PERCOLATION TESTING

HOWARD COUNTY HEALTH DEPARTMENT
BUREAU OF ENVIRONMENTAL HEALTH
3525-H ELLICOTT MILLS DRIVE/ELLICOTT CITY, MARYLAND 21043
TELEPHONE: 313-2640

From: Williams, Jeffrey
Sent: Wednesday, June 12, 2013 11:34 AM
To: 'tkeane'
Subject: CSB lot 6

From: Williams, Jeffrey [<mailto:jewilliams@howardcountymd.gov>]
Sent: Monday, July 8, 2013 4:01 PM
To: Rob Vogel
Cc: Tim Keane
Subject: RE: Tim Keane Chase at Stony Brook 6

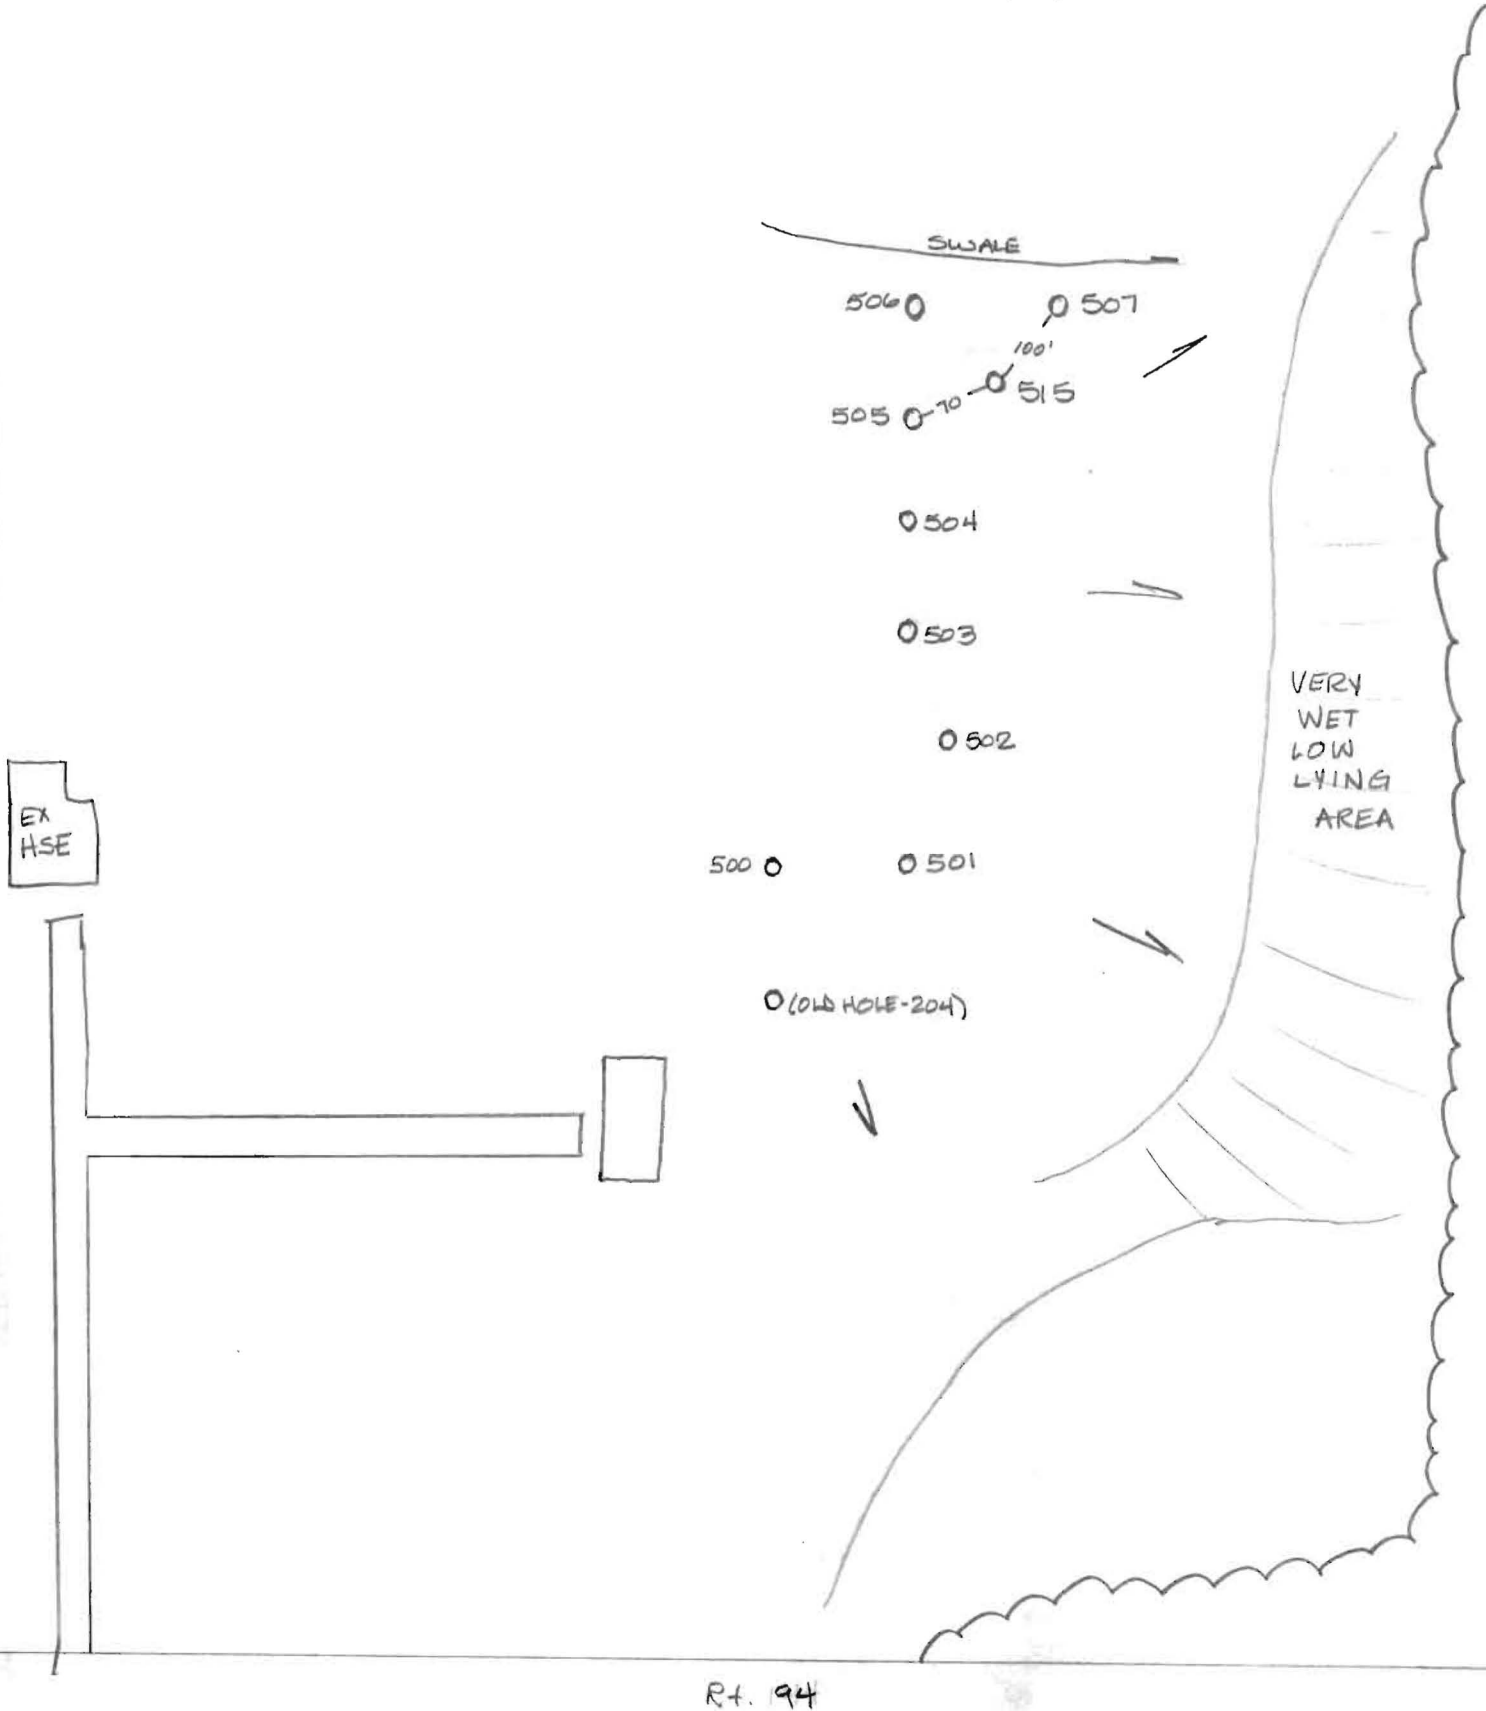
After reviewing the file, I see a letter from June 2012 from Dana stating what we need on a revised site plan:

- 3 well sites
- Perc hole locations and elevations
- 1 foot contours around the sand mound site

In addition we need to have the sand mound area and gravel bed area within the sand mound staked out in the field for our review. It doesn't look like any of that has happened yet. Once we get a revised plan with that info and get word of the areas staked out, we can take a look and move forward towards BP approval.

BED LAYOUT SCHEMATIC

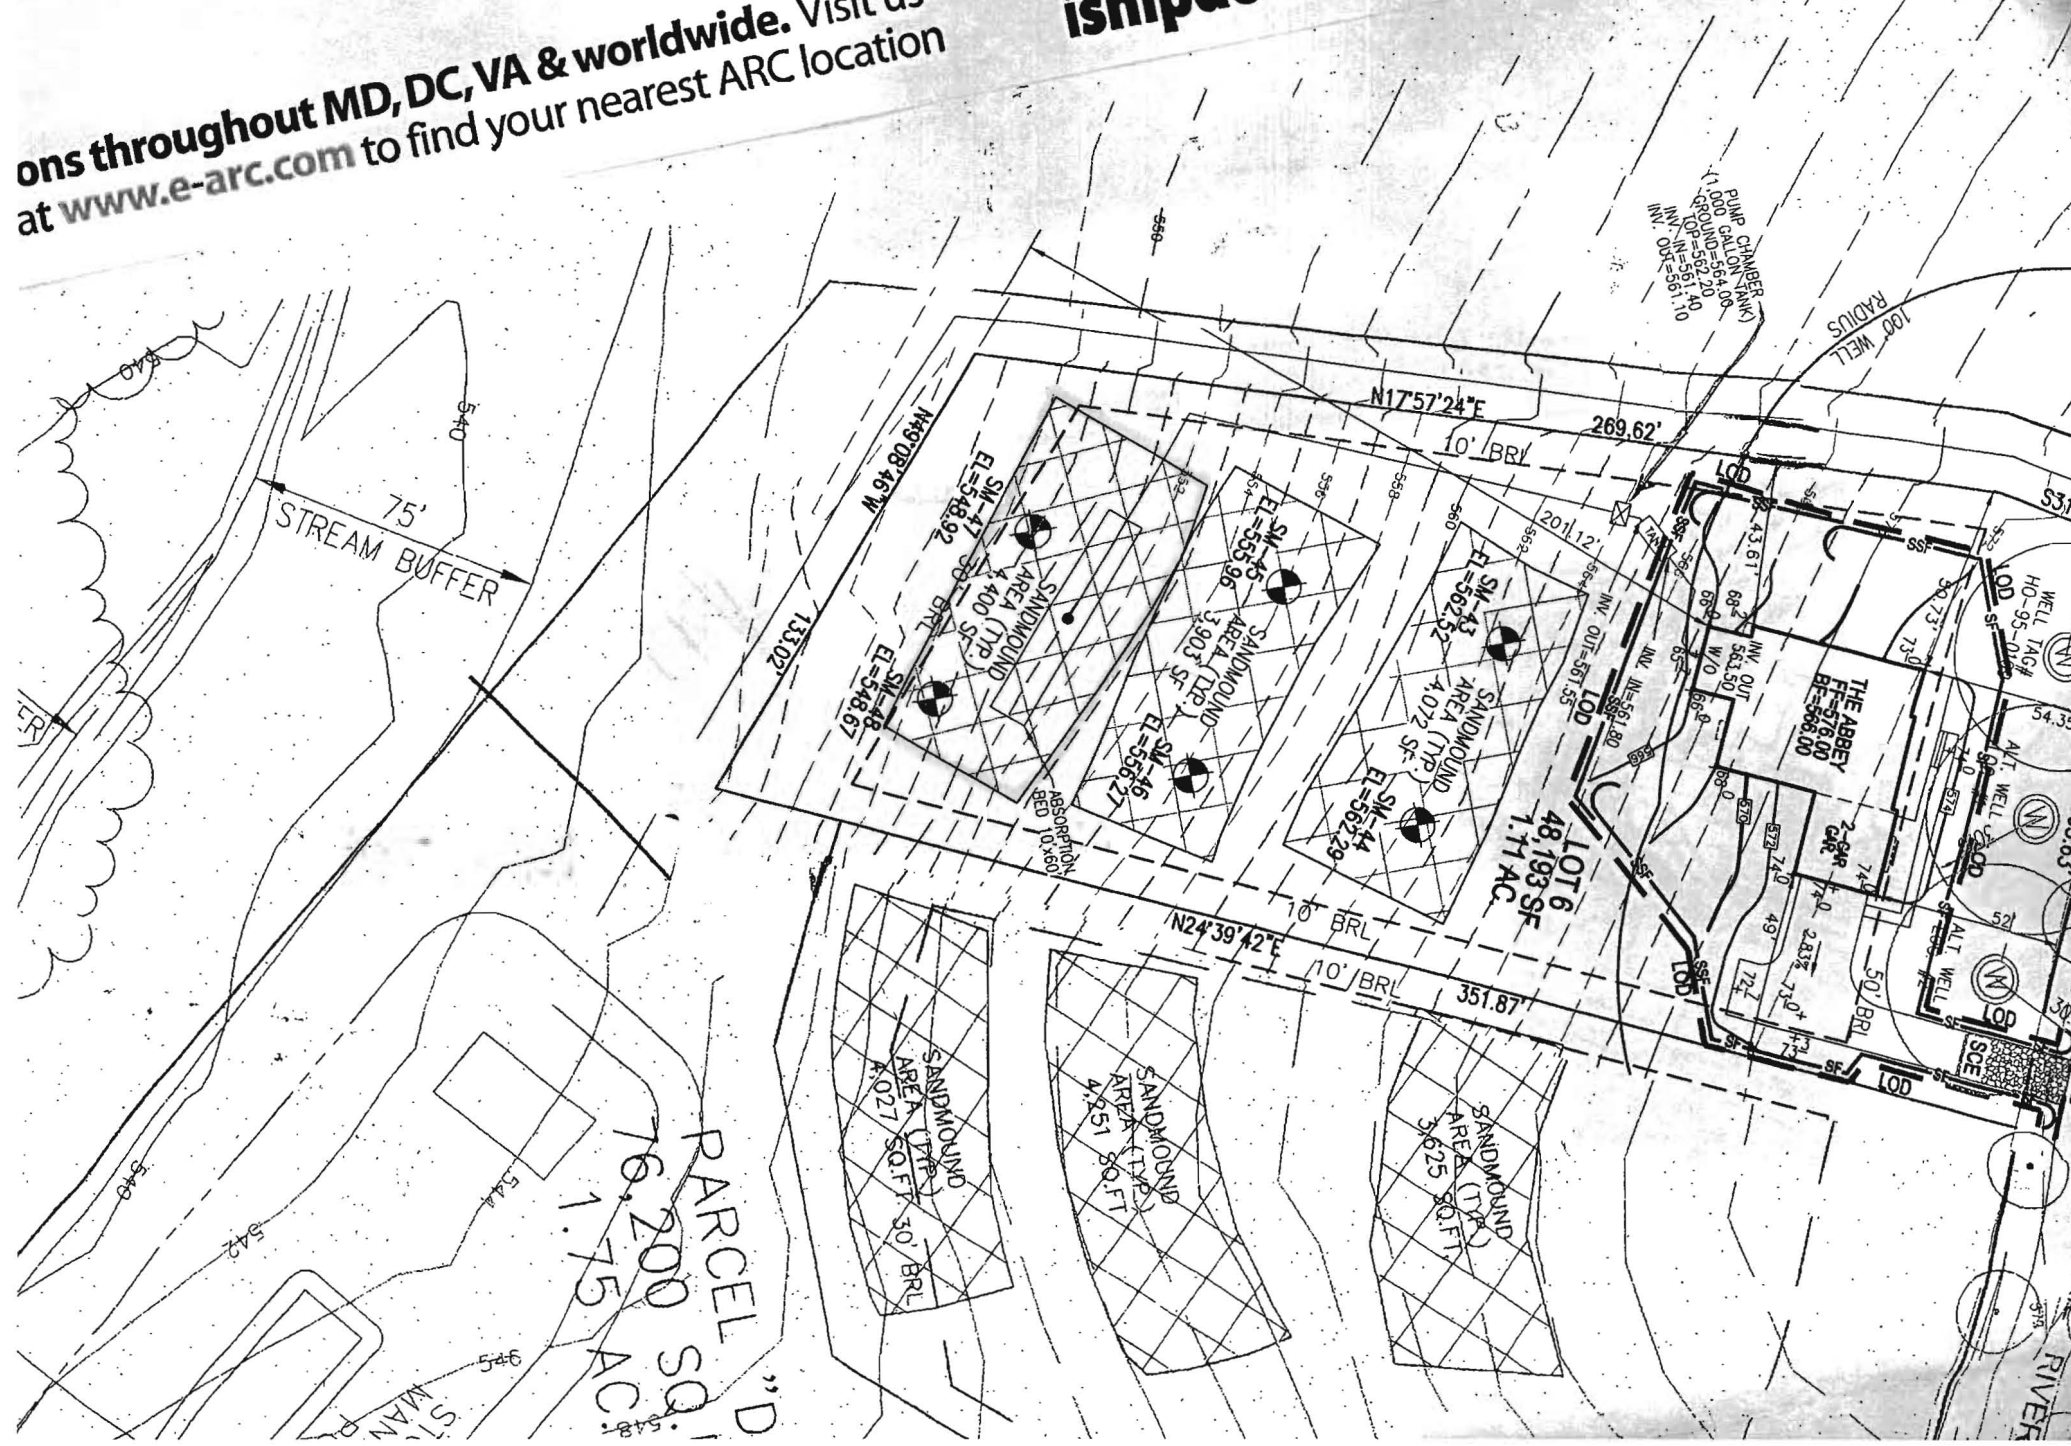
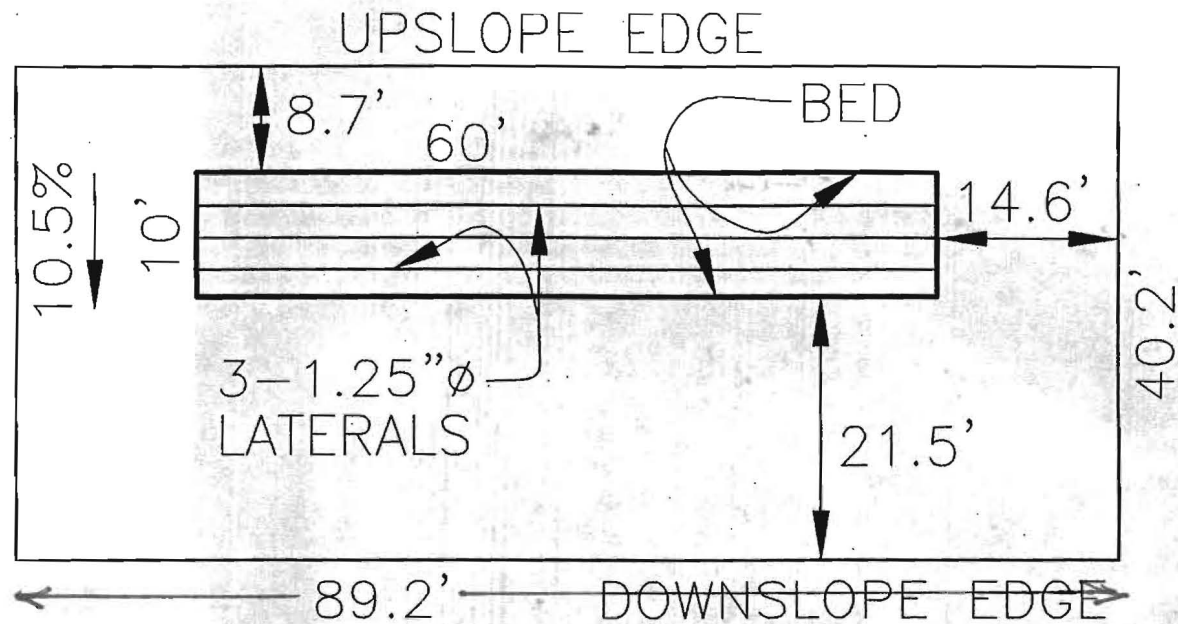
There was a miscommunication between myself and Dana. When Robert went out to look at the mound site, he noticed a graded drainage swale off the property nearby downslope. The mound site can be moved up 10' from its approved spot on the perc cert without interfering with the other mound site. We would like to see that site reflected on a revised septic plan to show it on contour and with the proper dimensions, but we don't need to do a revised perc cert. Also, we would need to see the new area staked out for our review prior to septic layout.

Can you please check the following comment from Dana? It is for Lot 6 Chase at Stony Brook. The sand mound design is within the box established by the signed percolation plat. Computations show 8.75 upslope setback and 21.1 downslope setback. The graphic shows about 7.5'-8' for upslope and about 23' for downslope. We can adjust the graphic slightly but this should not require a perc cert plat revision. Please confirm. Thanks.

The lot was reviewed and approved in accella. However, we will need a revised percolation certification plan to move the lower mound site up the hill 10 feet and show the edges on contour. We will need a revised percolation certification plan and the site will need to be restaked in the new spot prior to the septic layout.

This is going to be a bit of a tricky layout because the contours on paper do not exactly match what is found on site. For the paper submittal, I would like to see the top edge of the mound site to run on contour just below the 553 contour line. The gravel bed area should be shifted a bit to get it more or less on contour with the 551 contour line running through its middle.

In the field is the important part. We need the surveyors in the field to start at the lower left stake (as seen from below, the southwestern most stake, the lower stake on the same side as the pump tank) and move that 10' up the hill. From that stake location, they can move the rest of the mound to match that location. They should run the lower mound line along contour from that spot and stake the other bottom corner accordingly. Then, they can move the upper left (pump tank side) stake up according to the required mound width and find the upper contour to stake the other upper corner stake, keeping the minimum mound width in mind. They can then stake the bed area within the mound according to contour and the required upslope, downslope, and sideslope setbacks.

We moved the mound uphill 10 feet. Bottom left corner was near elevation 547+/-, this shifted uphill to near elevation 548. We then rotated the downslope edge onto the 548 contour.

Please see attached, the downslope edge generally runs along the 548 contour. The upslope edge (reading left to right) and the 9'x68' bed runs uphill. Would you like to amend this or should we proceed with detailing the septic plan?

-Noted, no revised perc cert is required.

-Per explanation above, please review and when acceptable we will forward a revised septic plan
